# Intel® Media Processor CE 3100

## Errata Update

*Revision 1.6*

Reference Number: E51472-001

**Figure 1. Serial Transport Interface Timing with Continuous DAV**

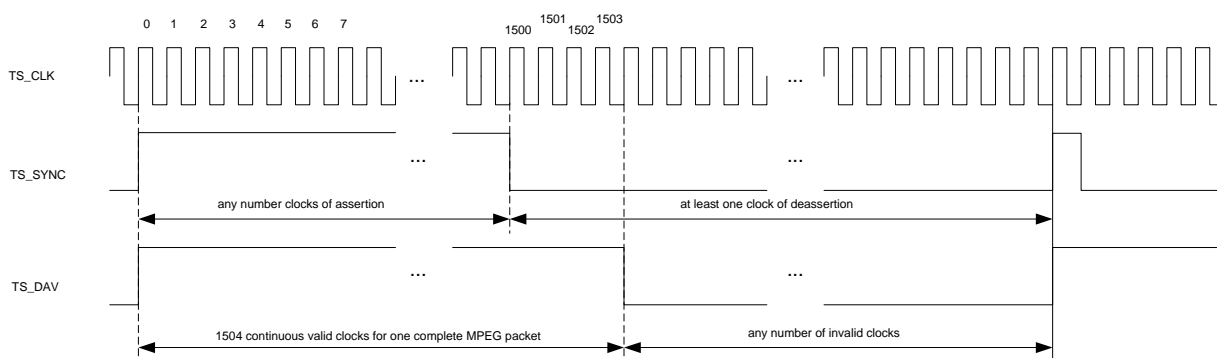
## 2. Transport Stream Timing Requirements:

Transport Stream devices must conform to the Intel® Media Processor CE 3100 required timing specs. Below are the timing diagrams that can be supported.

Note: Devices connected to the Intel® Media Processor CE 3100 serial transport stream input must conform to the timing specifications of the device. The Intel® Media Processor CE 3100 TS Input requires an even byte number of clocks for the 188 byte packet, and expects the data to be byte-aligned. Please refer to EMTS (Electrical Mechanical Thermal Specification) for detail information.
